1450 FREQUENCY RESPONSE TILT WITH TEMPERATURE

W2 Issue 13-23

2445/2465 POTENTIAL RELIABILITY PROBLEM

4054/4054A Q5001 AND Q5002 MODIFICATION

Figure 1

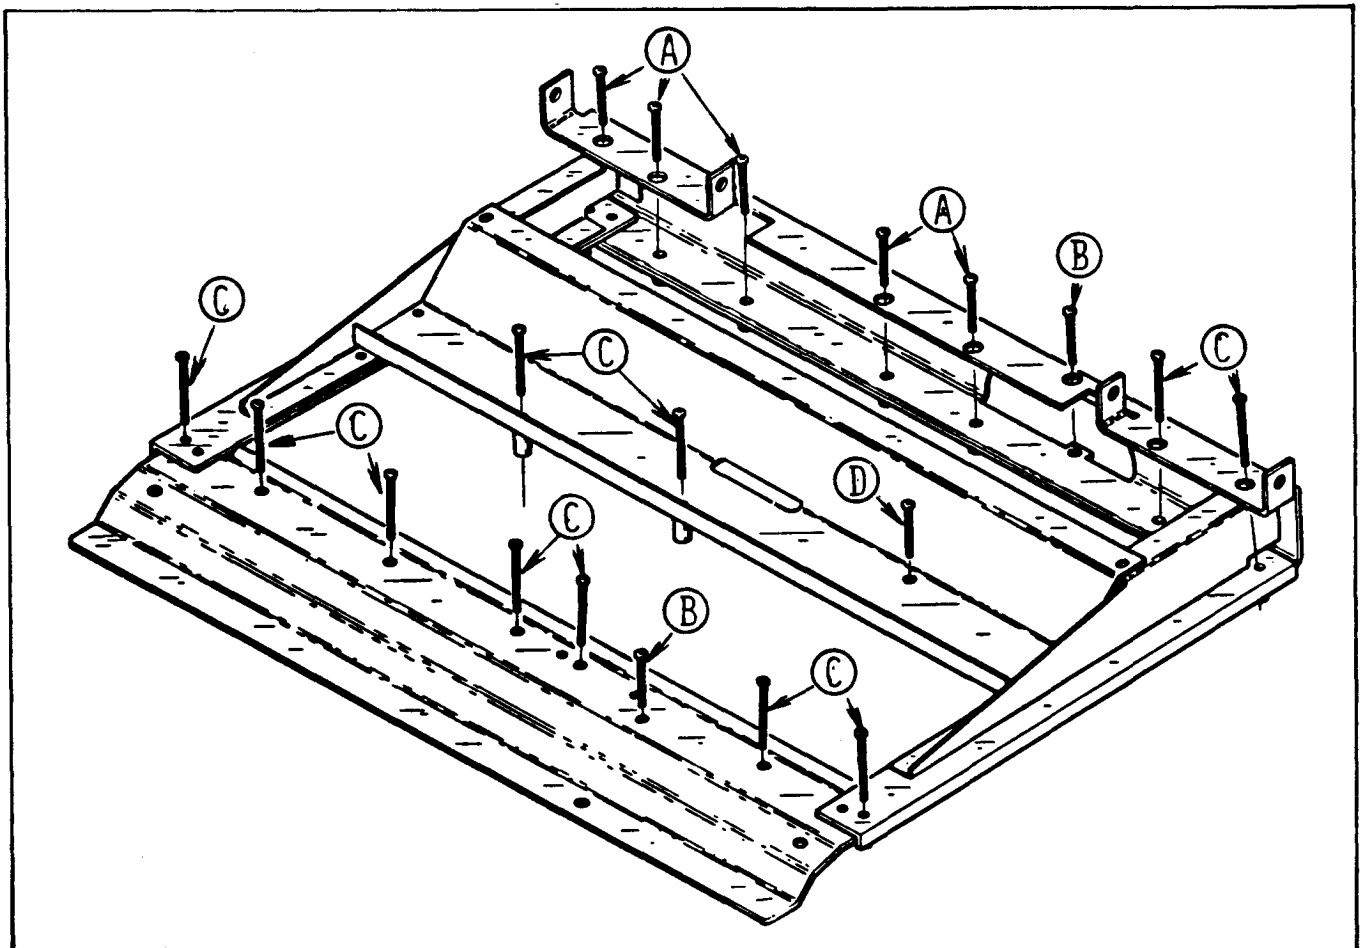
Questions have filtered in from different field personnel concerning the length and placement of the screws which hold the CPU sandwich to its frame assembly. The figure below shows the frame assembly, the screws and the holes which the screws are inserted through. Note circled alpha characters, each denote a different length screw. Following the figure is a table for cross-referencing the index character to screw length.

Note that there are two "D" type screws listed. On the 4054A this screw goes through the ALU board and into the I/O board, whereas on the 4054 it only screws to the ALU board.
